Site: Inspiration Subdivision at Arroyo Vista Blvd/ 118th St. NW – J08E005

Re: Drainage Ordinance (14-5-2-11) Violations for Erosion and Sediment Control

This Notice of Violation #2 pertains to observation during City Follow-up inspections on 9/1/22 and 9/15/22.

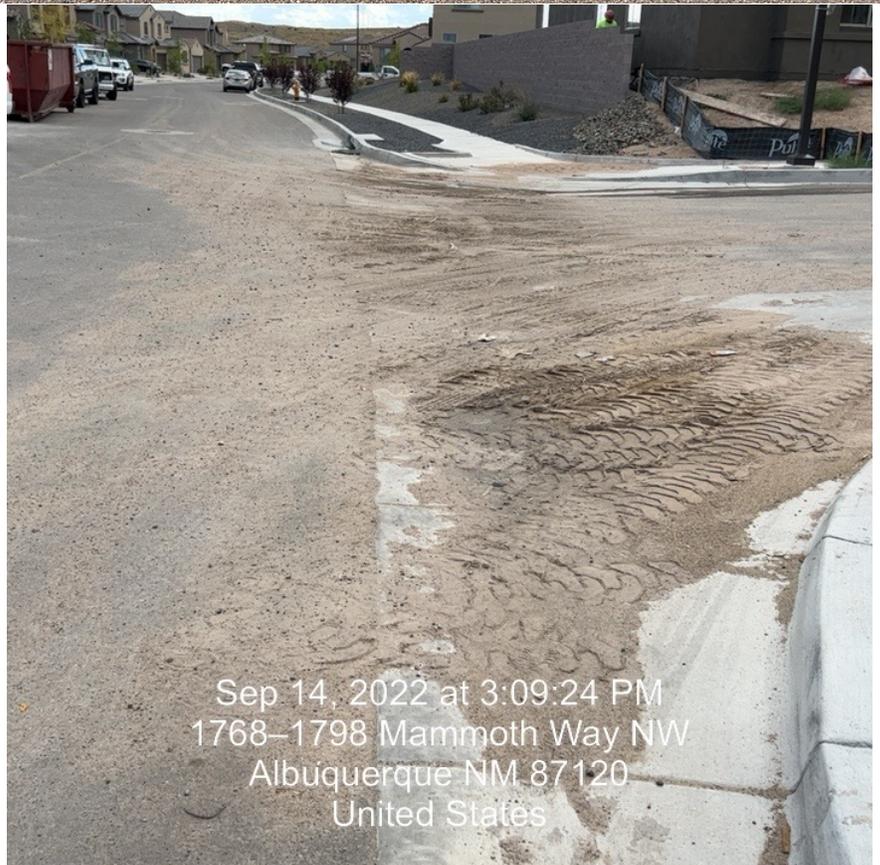
1. Sediment was on the AC Trail at the west end of Arroyo Vista Blvd.

and in the Albuquerque Regional Sports Complex parking lot (Previously reported 7/14/22 and 8/8/22).

Sediment was also on several onsite streets and sidewalks throughout the site. (Previously reported 4/21/21, 7/14/22, and 8/8/22) All of the street and utility construction is complete and is serving the public. Housing construction is about 60% complete and the houses are occupied. The onsite streets discharge stormwater runoff into the City's MS4 system.

1. Where sediment has been washed or tracked out onto paved roads, sidewalks, and parking lots remove the deposited sediment by the end of the same business day CGP 2.2.4.d. Most of the existing instances of sediment in the street have been there longer than 7 days so they must be escalated from Routine Maintenance to Corrective Actions.

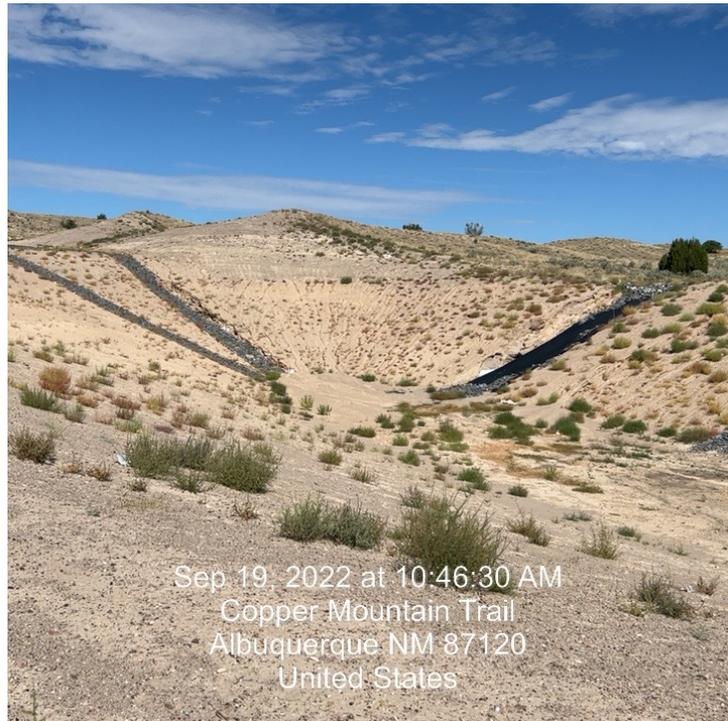
2. BMPs –Cut-back swales behind the curbs are not keeping sediment out of the streets.

Silt Fence repairs, replacement, and additions are needed in several locations along the northern perimeter. Additional Silt fence is needed at the above photo of Badger Mountain Trail.

- a. Better perimeter controls need to be established per CGP 2.2.3.c.ii around each lot and block to keep sediment out of the streets and off of the sidewalks. The City standard cut-back detail says to use check dams or silt fences to slow stormwater runoff down on steep (>2%) streets. Modify the SWPPP accordingly.

Washout by the construction trailer.

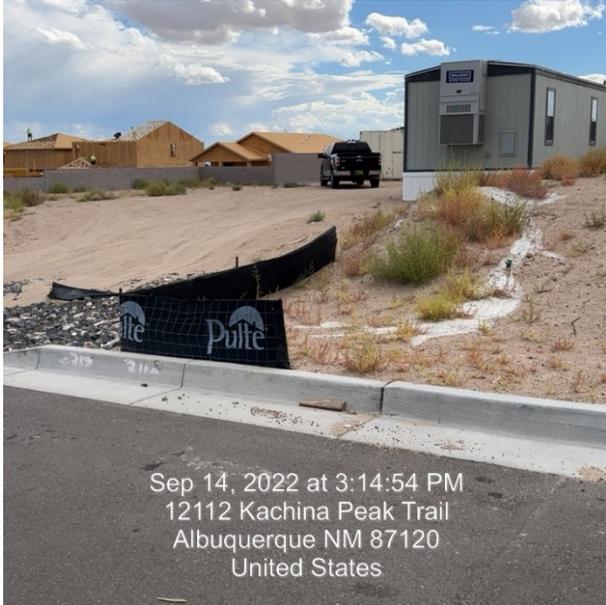
5. Washout of concrete, stucco, and paint is on the ground at many of the houses under construction and at the concrete washout in the northeast corner of the subdivision. Lined containers were absent. Washout had overflowed and was still sitting on the ground at the sign.

No liner could be found at the main washout or anywhere else.

Washout on Mammoth Way.

Curb cut is another form of concrete wash water.

- b. Permit coverage is required for the Inspiration Community Association, LLC., and the transfer must be shown on Pulte's SWPPP map. Their NOI should either be added to the Pulte SWPPP or another SWPPP will be required for the Association.
5. Direct wash water from concrete, paint, and stucco into a leak-proof container and never onto the ground per CGP 2.3.4. Provide lined containers at the primary washout location and at convenient locations for each house during such construction. Remove and dispose of hardened concrete with other waste in per CGP 2.2.3.
6. Support all portable toilets to prevent tipping per CGP 2.2.3.f.
